Intel[®] Mobile Celeron[™] Processor at 466 MHz, 433 MHz, 400 MHz, 366 MHz, 333 MHz, 300 MHz, and 266 MHz Specification Update

Release Date: November 2000

Order Number: 244444-020

The Intel[®] Mobile Celeron[™] processor at 466 MHz, 433 MHz, 400 MHz, 366 MHz, 333 MHz, 300 MHz, and 266 MHz may contain design defects or errors known as errata which may cause the product to deviate from published specifications. Current characterized errata are documented in this Specification Update.

Figure 2. Workaround Flowchart: SMBALERT#-Driven System

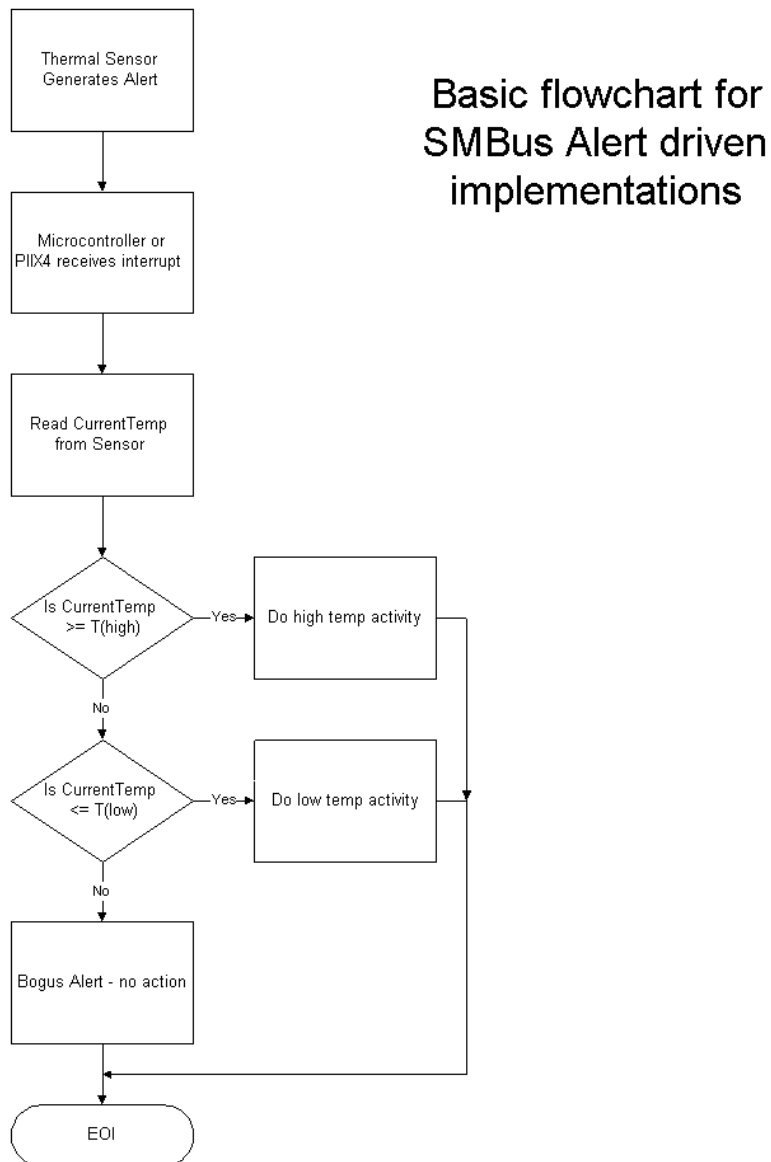
H29. Thermal Sensor May Assert SMBALERT# Incorrectly

Problem: The Intel Celeron Processor Mobile Module has a thermal sensor that monitors the processor core's temperature. Please note that desktop systems could have a similar thermal device. The thermal sensor asserts SMBALERT# if the processor temperature exceeds the temperature limits set in the Alarm Threshold Registers (T_{HIGH} , T_{LOW}). It also sets the corresponding Status Register bits to identify the cause of the interrupt. Figure 1 gives one example of the how the SMBALERT# signal could be used in a system.

Workaround: Three different (mutually exclusive) workarounds are possible:

1. Before servicing an interrupt from the thermal sensor, read and compare the processor thermal reading with the threshold limits (T_{HIGH} or T_{LOW}). Figures 2 and 3 provide basic flowcharts for the implementation of this workaround in an interrupt driven system.
2. If the firmware implemented polls the Status Register only, then before taking any action, re-read the temperature register and do a comparison with the alarm threshold limits (T_{HIGH} or T_{LOW}) to determine if the value is actually still within the temperature window.
3. Use a temperature polling scheme to monitor the processor temperature.

Figure 5.4. Surface-Mount BGA1 Package—Bottom View

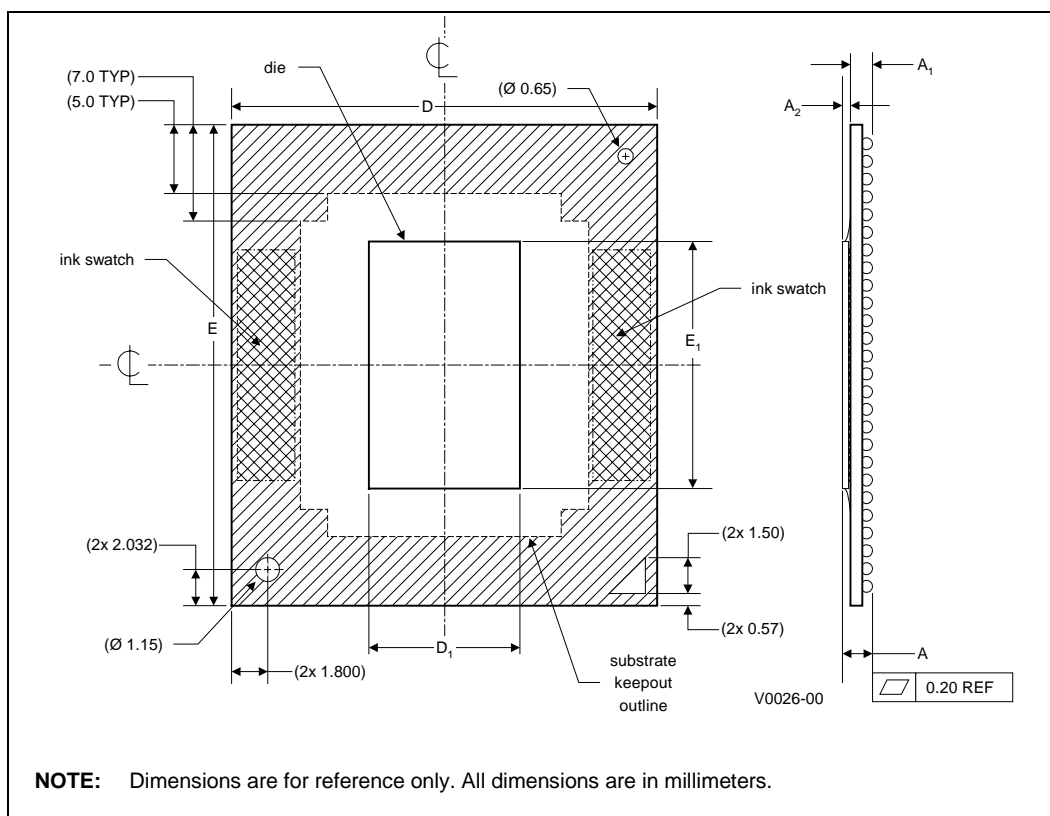
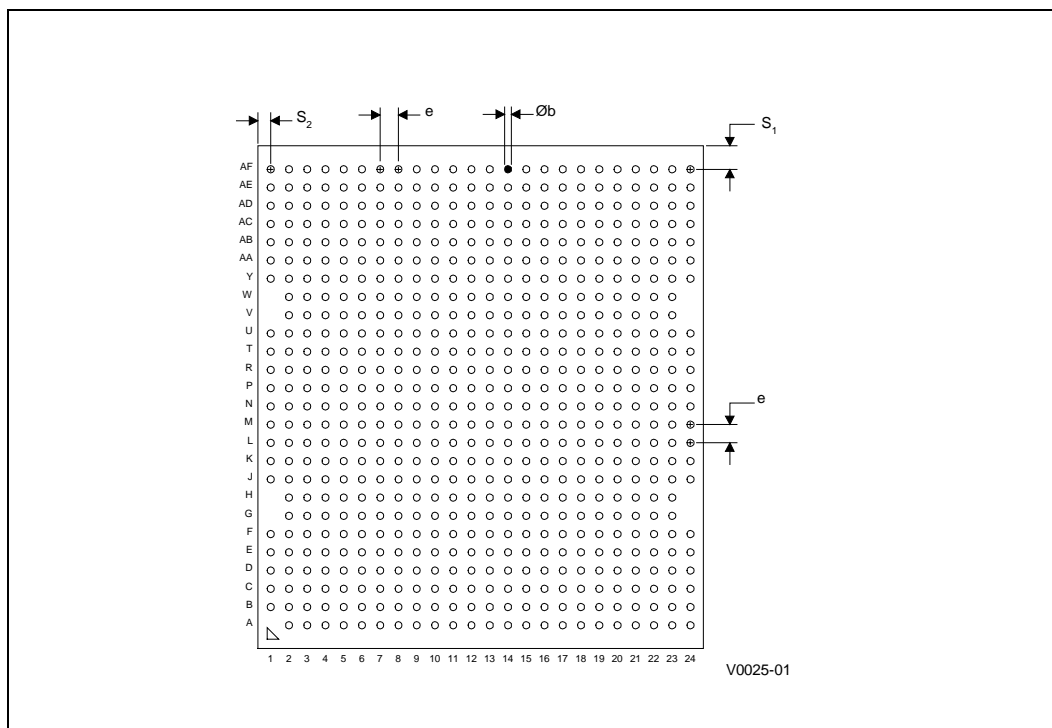
The following table and figures show the updated mechanical specifications for the BGA1 package, listed as Table 5.2, Figure 5.3 and 5.4, respectively, in the *Intel® Mobile Celeron™ Processor in BGA Package at 333 MHz, 300 MHz and 266 MHz* datasheet.

1. The number shown here is different from that in the 244444-004 version of this specification update. The maximum reference number is used.

Figure 3.3 Generic Clock Waveform

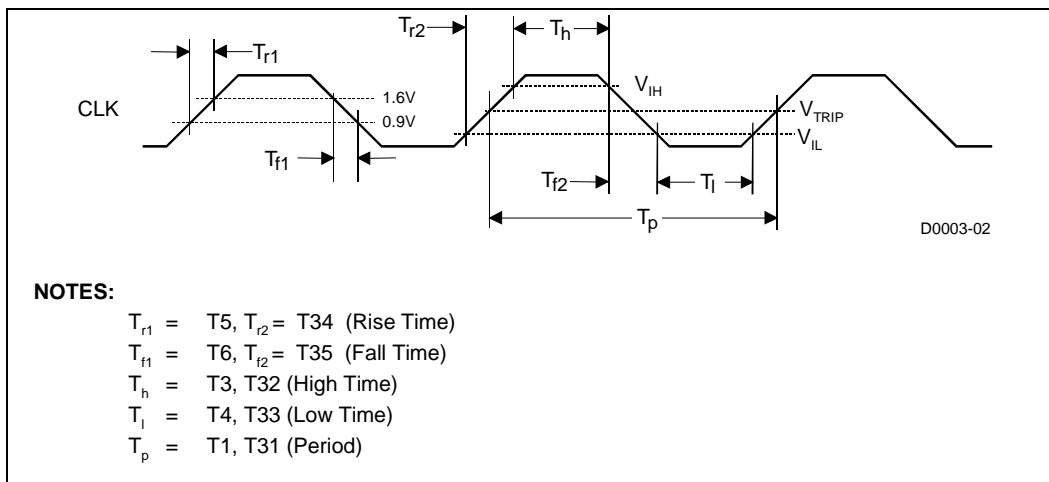
H11. Generic Clock Waveform Figure

Figure 3.3 in the *Intel® Mobile Celeron™ Processor in μ PGA1 and BGA1 Packages at 366 MHz, 333 MHz, 300 MHz, and 266 MHz* datasheet (Order Number 245112-003) has been updated. The following figure is to replace the one in the above document.
